INDESIT company

Model type:
DFG262SEU

Commercial code:
F061124

n4513g02: INTRODUCTION OF NEW SYNCHRONOUS MOTOR

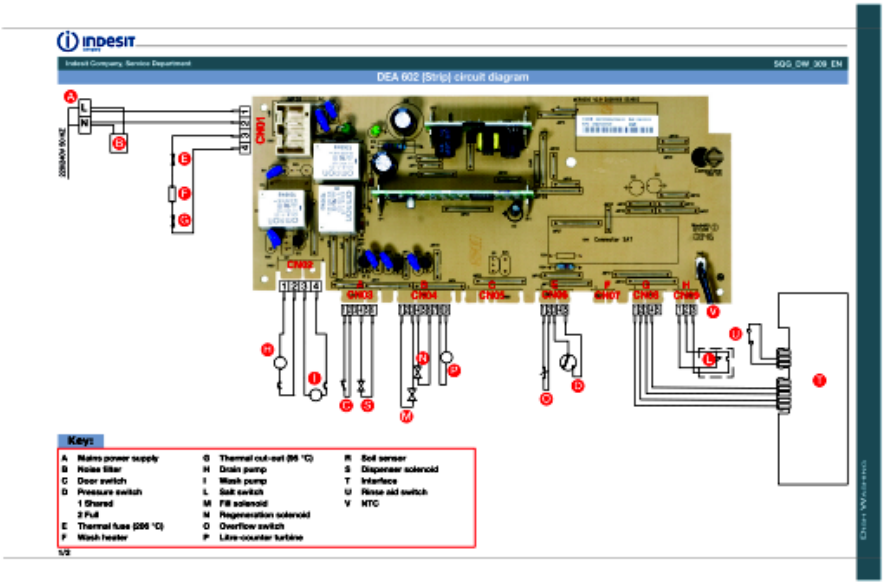
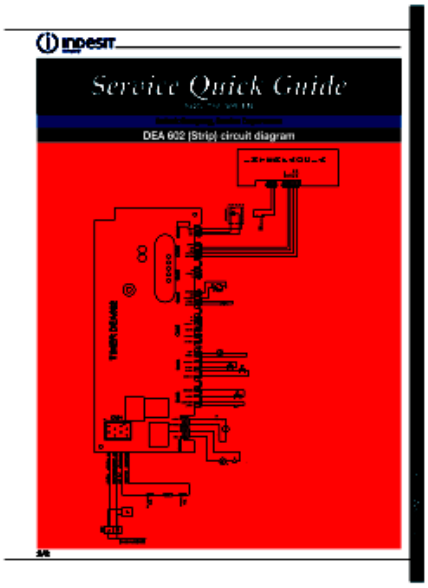
A new electropump has been introduced in the synchronous motor. This is perfectly interchangeable with the previous one, only the dowel has been modified improving its quality.

New motors have new codes:

Old New
C00256523 -> C00302800
C00256525 -> C00302798
C00272798 -> C00302796
